# Access Compliance Report

## Public Rights-of-Way

### (Curb Ramps)

Intersection ID: 49894	Main Street: ROCKY_FORD_CLUB_RD	Cross Street: RUTH_FERRELL_CT	Location:	N
ADA ID: 6B8C29266D03	Ramp Type: BlendTrans1	Initial Pass/Fail: Fail	Overall Compliance: No	Severity Score: 8.75
Codes/Mitigation Info/Possible Solution		Field Measurements/Component Compliance

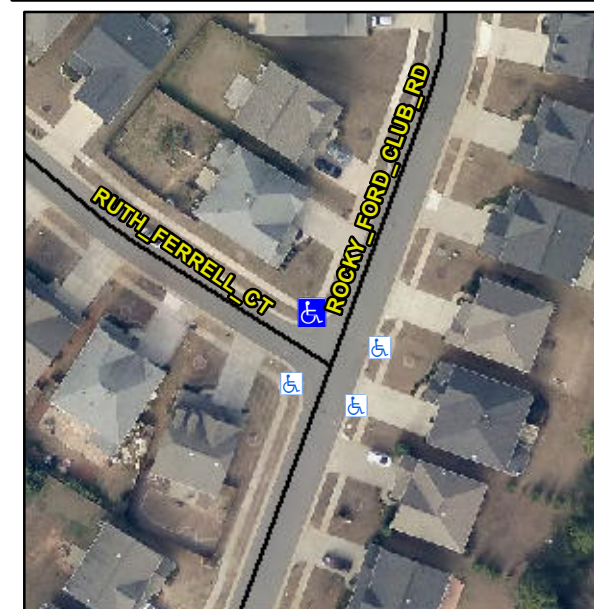
**LNDG GAP 2.0**

**Not Found, R304.5.1**

**Remove & Replace Curb Ramp With Two New Directional Ramps or Equivalent.**
